P/4/18/PL

PLAN-022006

Proposal: Erection of 1No. 4-bedroom house and 2No. 3-bedroom bungalows including shared use of existing vehicular accesses to convenience store and associated parking, landscaping, bin and cycle storage. This application may affect the setting of a Grade 2 Listed Building.

Site: Land at former Kings Beach Hotel, 5 The Parade, Bognor Regis, PO21 4TW.

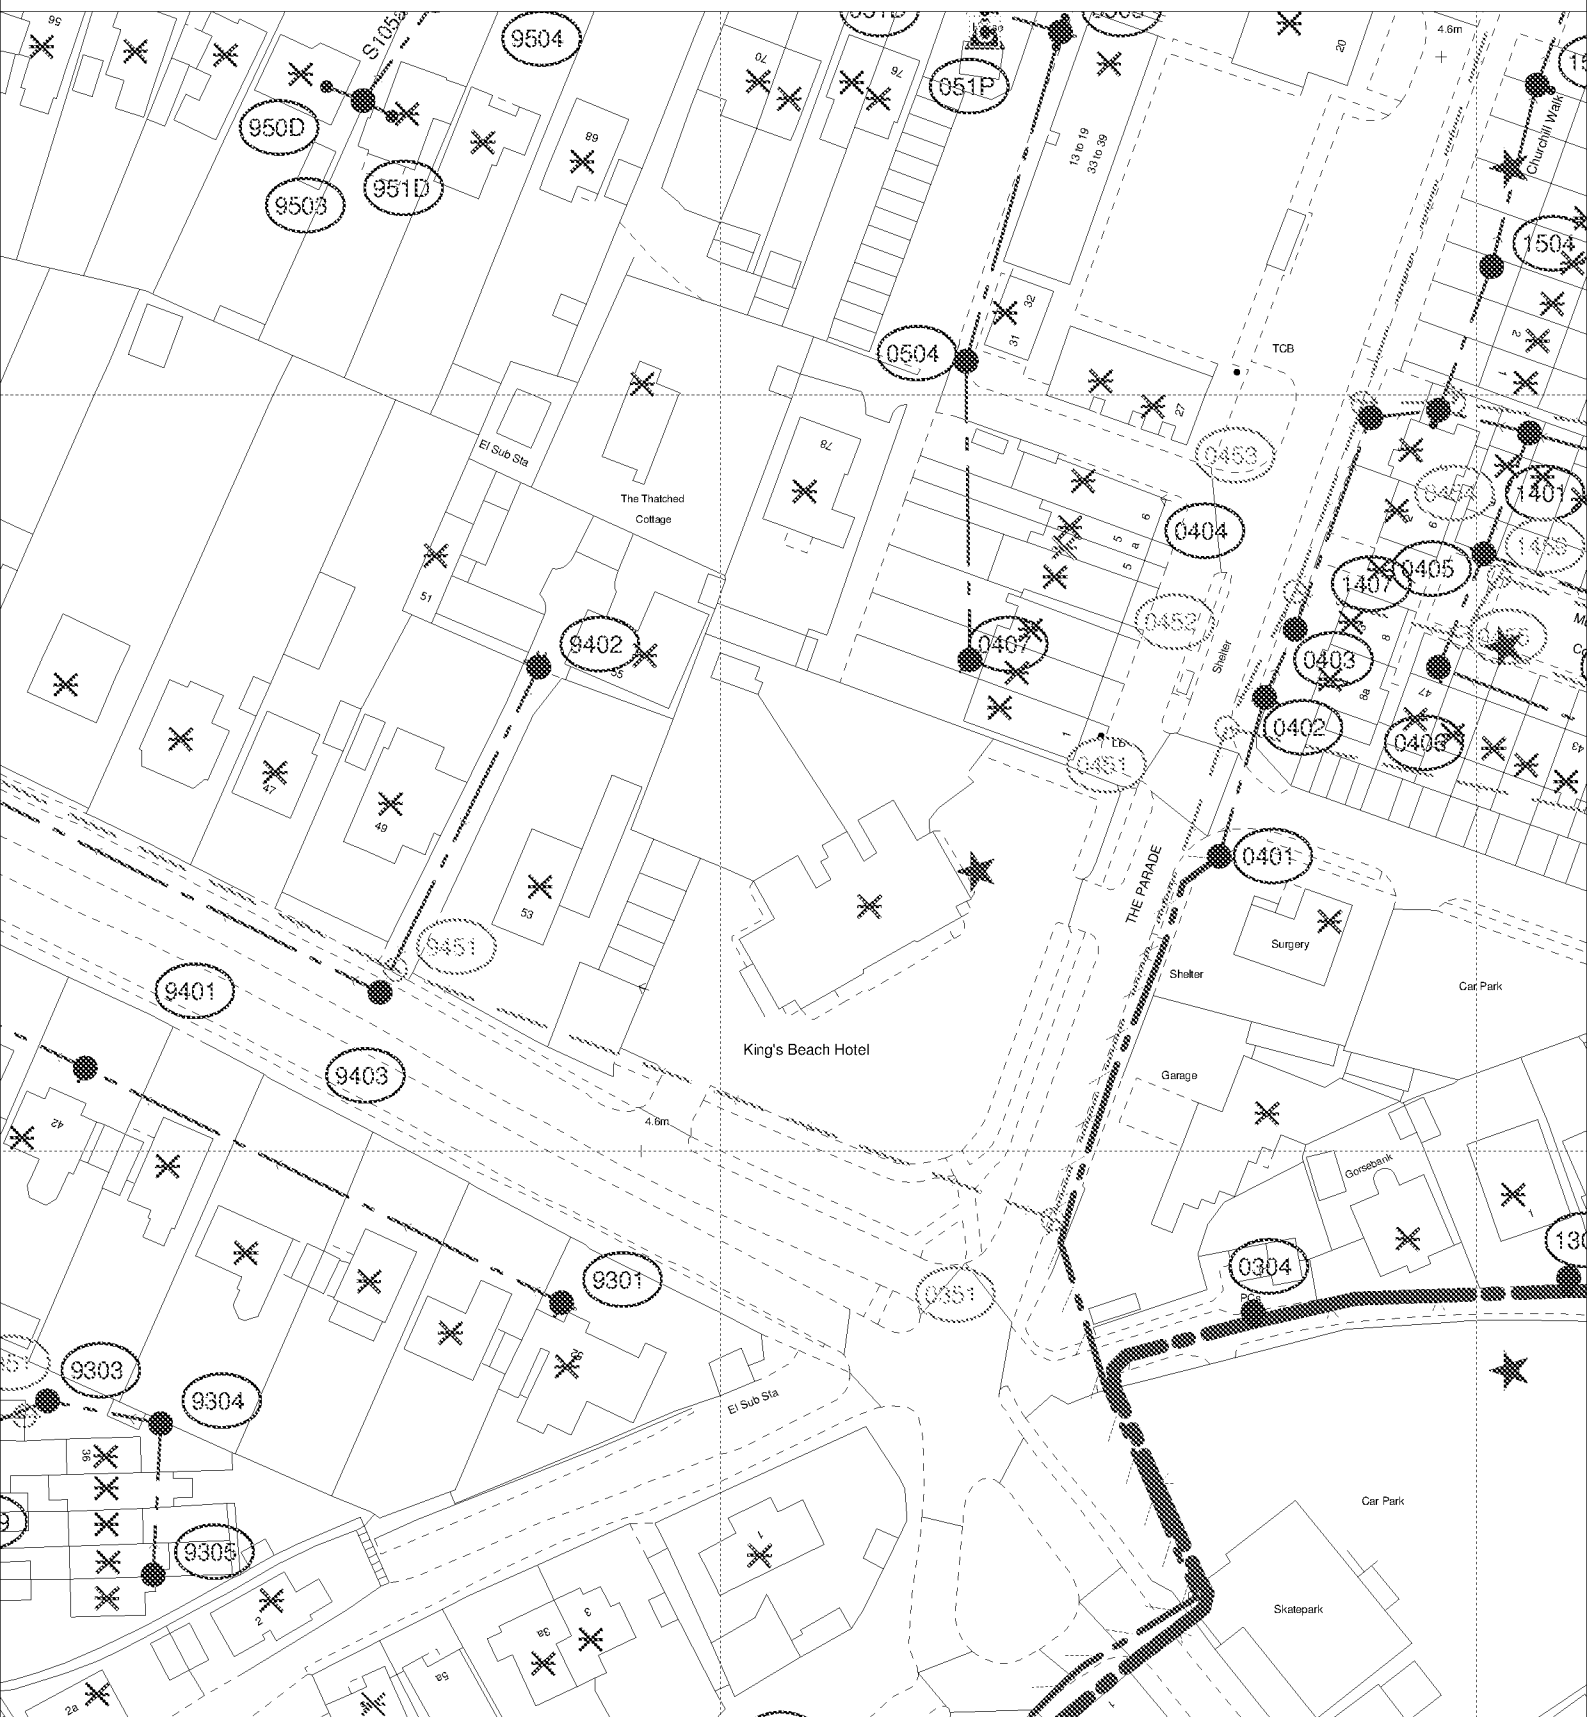
Please find attached a plan of the sewer records showing the approximate position of surface water sewer within the site. The exact position of the surface water sewers must be determined on site by the applicant before the layout of the proposed development is finalised.

- No development or new tree planting should be located within 3.5 metres either side of the external edge of the surface water sewer.
- No new soakaways should be located within 5m of a public sewer.
- All existing infrastructure should be protected during the course of construction works.
